In the Matter of)	
)	
Amendment of Part 27 of the)	
Commission's Rules to Govern the)	WT Docket No. 07-293
Operation of Wireless Communications)	
Services in the 2.3 GHz Band)	
)	
Establishment of Rules and Policies for the)	IB Docket No. 95-91
Digital Audio Radio Satellite Service in the)	GEN Docket No. 90-357
2310-2360 MHz Frequency Band)	RM No. 8610
)

REPLY COMMENTS OF XM RADIO INC.

March 17, 2008

Figure 122 New York City Realistic WCS Base Station 30 m Receive Levels Coverage Map > -30 dBm

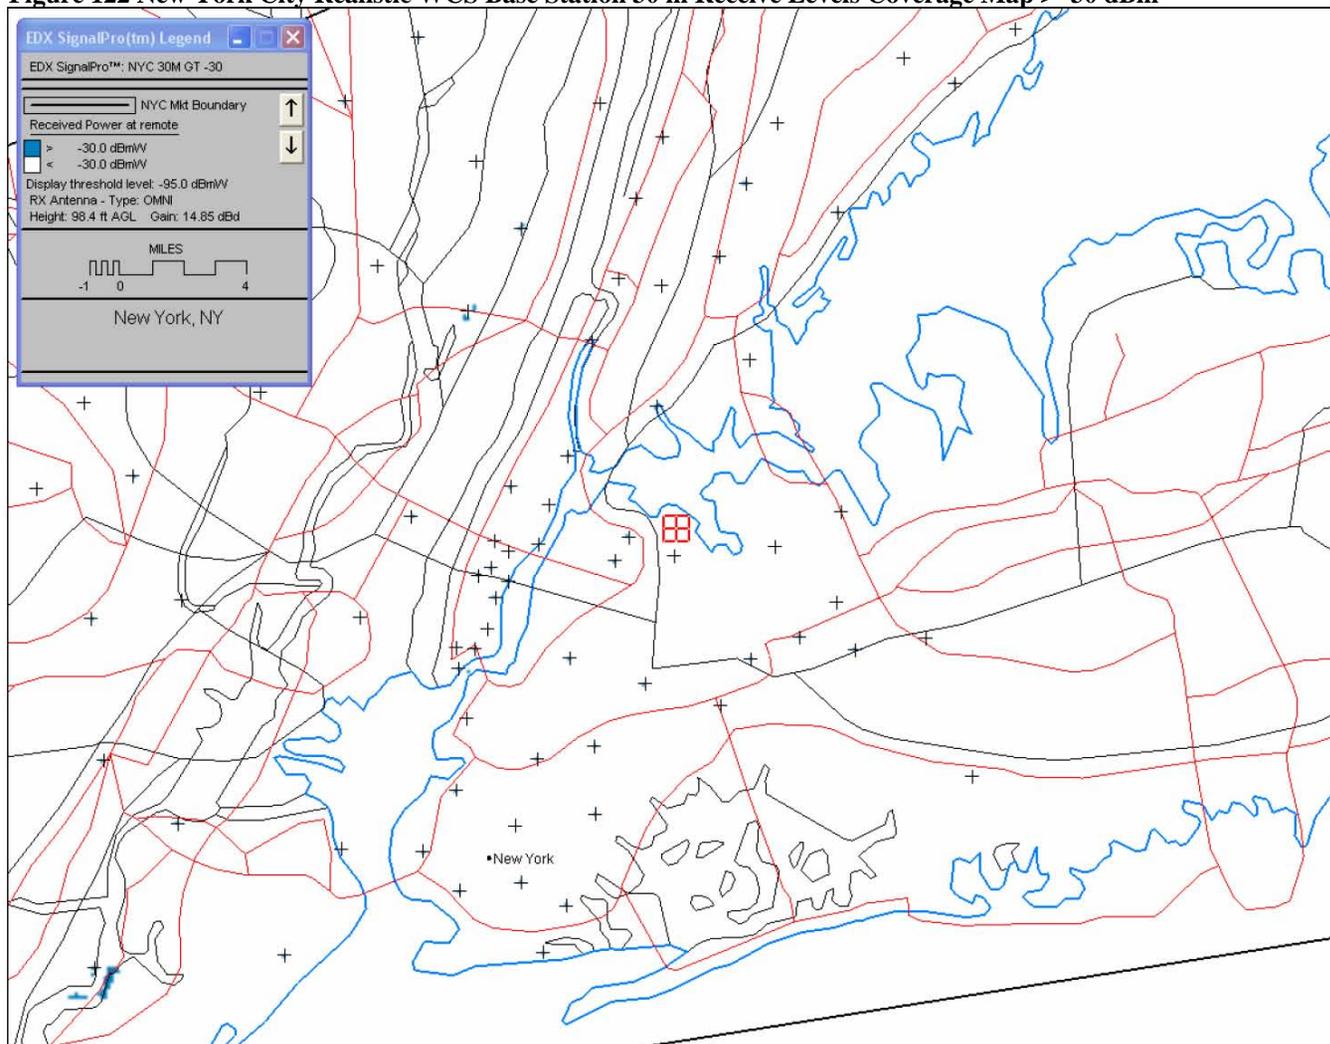
Notably, the WCS Coalition couches its proposal as a concession. The Coalition attempts to show that WCS base stations would suffer interference if its proposal is adopted by providing a map depicting interference zones that would cover Washington, D.C., and New York City if SDARS terrestrial repeaters were granted OOB relief as well. However, given the fact that SDARS terrestrial repeaters already comply with a much more stringent OOB limit based on equipment design, the Coalition's showings — and its concession — have little meaning. WCS base stations will not suffer from SDARS OOB.

The blue areas show the predicted XM terrestrial signal level > -30 dBm at the WCS base station antenna terminal, 30 m AGL.

Figure 133 Washington, DC Realistic WCS Base Station 30 m Receive Levels Coverage Map >-30 dBm

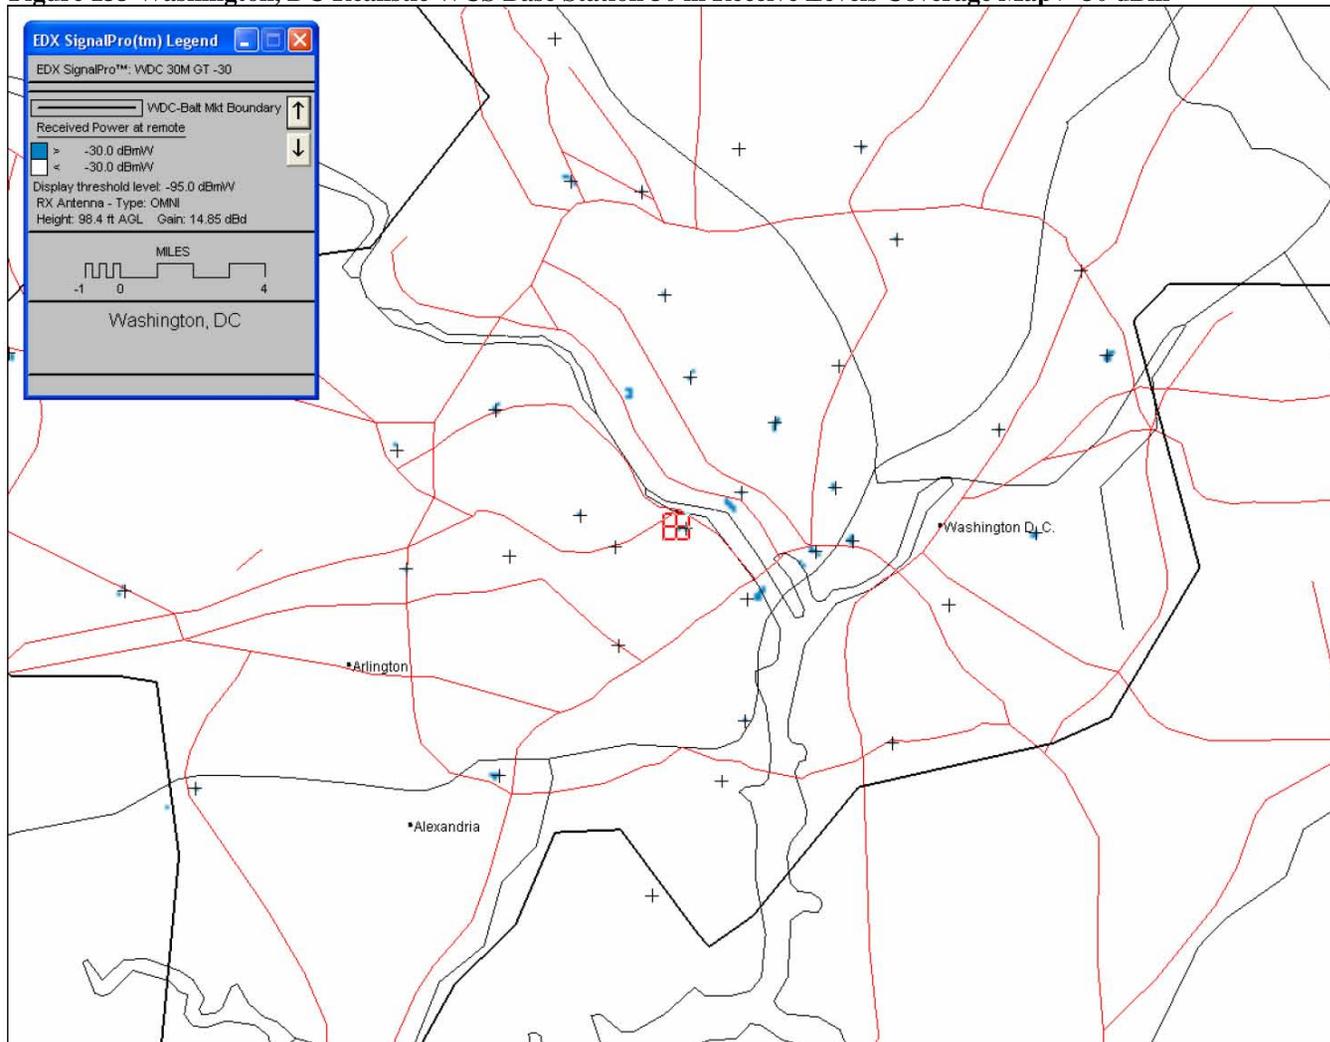
The blue areas show the predicted XM terrestrial signal level > -30 dBm at the WCS base station antenna terminal, 30 m AGL.

Figure 2 Measured Peer to Peer Path Loss at 2.1 GHz ⁹

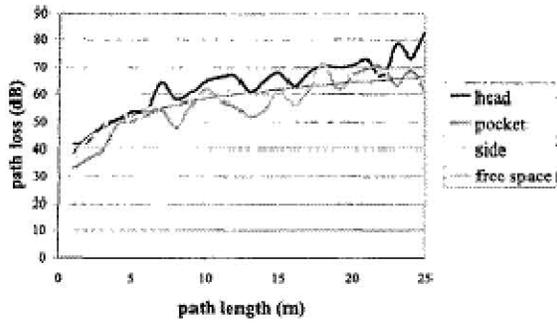
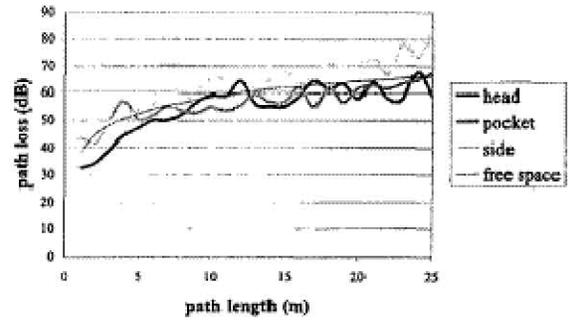
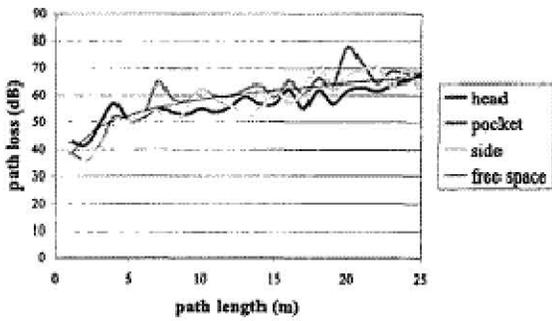
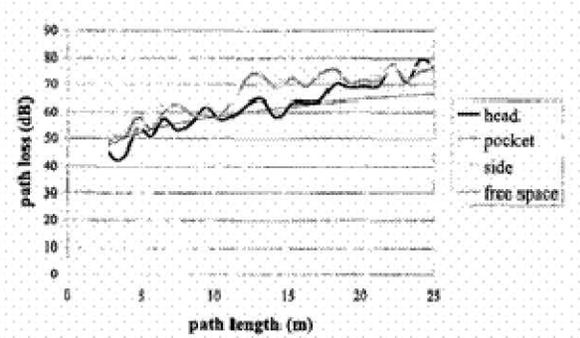
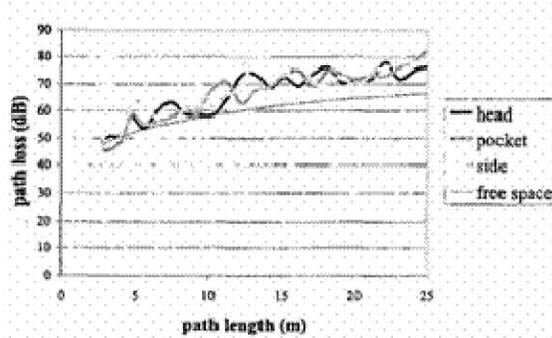
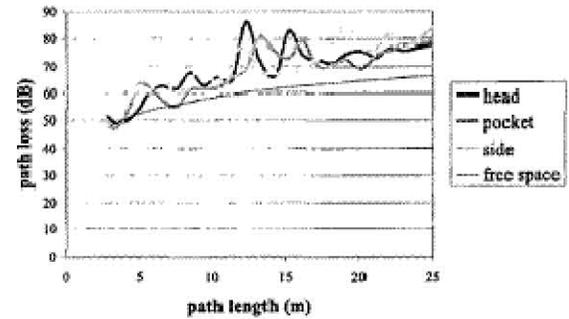
The results in Figure 2 show measurements made at 2.1 GHz under a variety of conditions (line of site and non line of sight) for a transmitter and a receiver at low heights and separated by distances up to 25 meters.⁹ Only a small difference in path loss would be expected between this data and that at 2.3 GHz. At 3 meters, a path loss of 50 dB or less would be seen under these types of circumstances.

Figure 3 Predicted Path Loss (from NTIA Report)

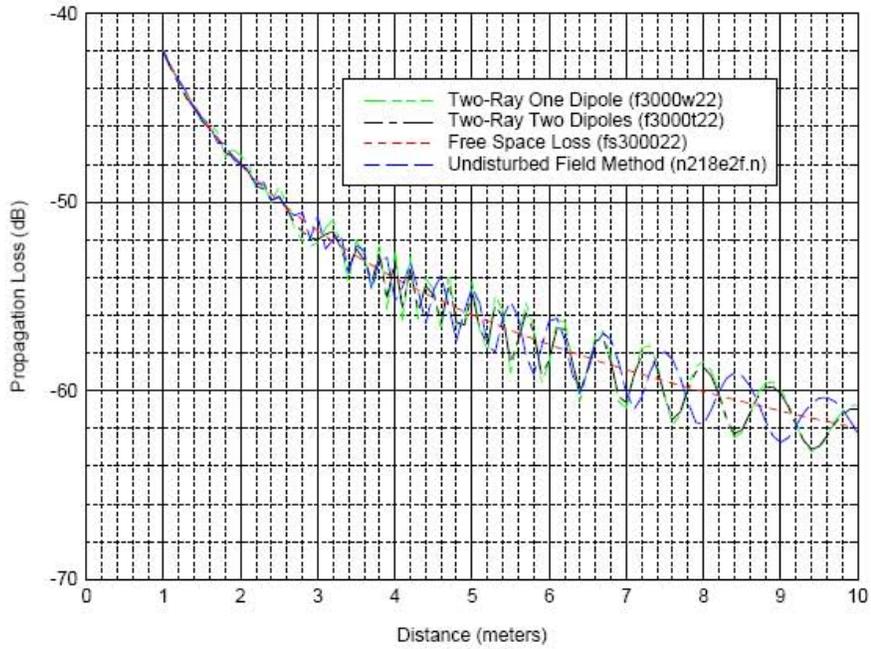
One of the results from the recent comprehensive NTIA evaluation of mobile to mobile propagation loss modeling is shown below in Figure 3, Predicted Path Loss (from NTIA Report). This too, allowing for the slightly different frequencies puts the expected path loss at 3 meters at approximately 50 dB.

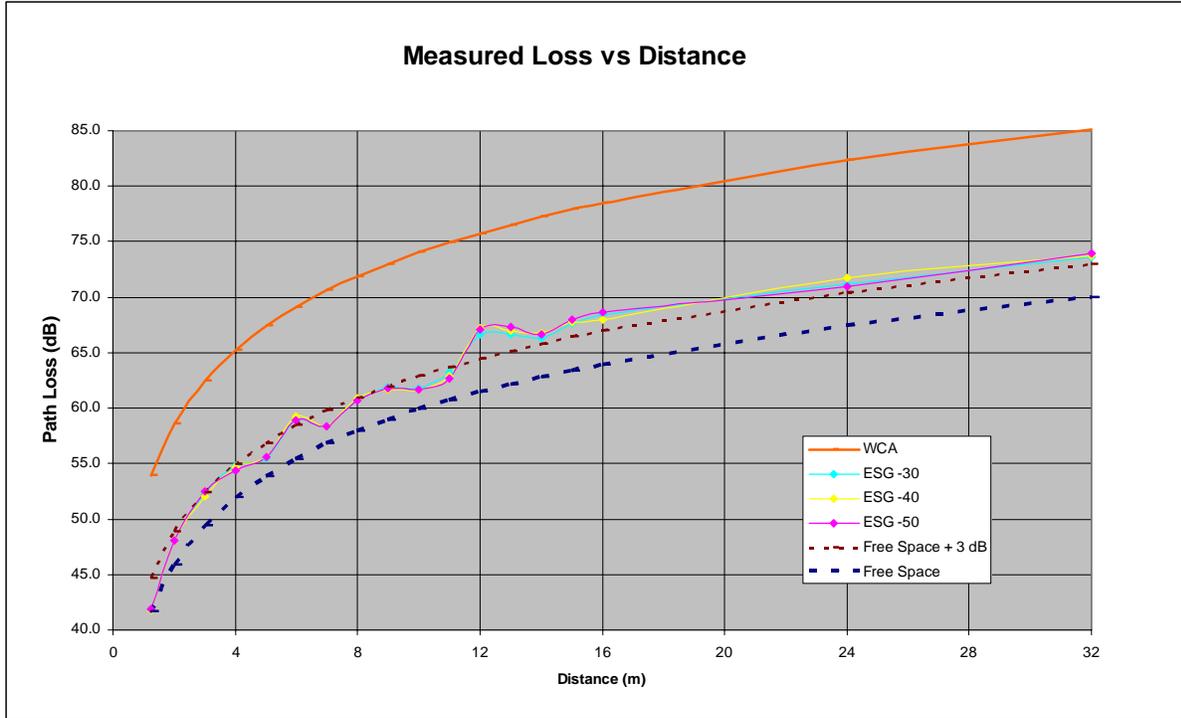
The plot below illustrates that XM's path loss vs. distance measurements validate the expected path loss used by XM (free space path loss + 3 dB) to determine the WCS interference impact on XM receivers. The plots show each of the data points for various ESG

power levels (shown on the legend as ESG-30, ESG-40 and ESG-50). As demonstrated, the collected data points match up closely with free space path loss + 3 dB. Also shown is the path loss curve proposed by the WCIA which is at least 10 dB greater path loss than can be expected.
